Subject: Response to Colton Joint Unified School District Comments on the Bloomington Center

Project the Draft Initial Study-Mitigated Negative Declaration

This memorandum includes responses to comments received from the Colton Joint Unified School District (CJUSD) during the circulation of the Draft Initial Study-Mitigated Negative Declaration (IS-MND) prepared for the P-2019-00079 Bloomington Center Project (project).

Storage Tank Locations Figure A-1

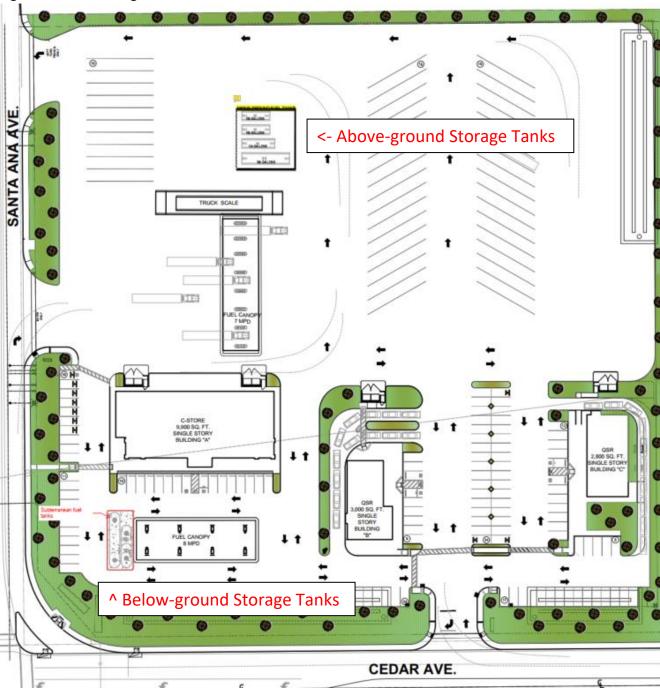
- Page 2. Proposed Project includes eight fuel dispensers and seven diesel bays. The Project Description states that fuel tanks would be provided on lot 6. However, it is unclear from the Site Plan (Figure 3) where the specific location of these tanks will be. The Project Description should include a discussion of the location of these fuel tanks, and project design features and maintenance measures put in place to ensure that such tanks are safe from cracks, breaks, and leaks. Additional specific questions include:
 - Will these fuel tanks hold fuel for both the multi-fuel pumps on the west side of the Proposed Project and the diesel tanks toward the east side of the Proposed Project? Or are there separate tanks proposed for the west side of the Project Site?
 - o Will these tanks be above ground or subterranean?

See Figure A-1, below, for a site plan that displays the current positioning of the fuel tanks. Some tanks will be above ground on the eastern portion of the site, and would be screened from surrounding uses. Other tanks would be underground located next to the fueling stations on the western portion of the site. In regards to maintenance measure, the project would adhere to the Certified Unified Program Agency requirements (CUPA is the Hazardous Materials Division of the San Bernardino County Fire Department).
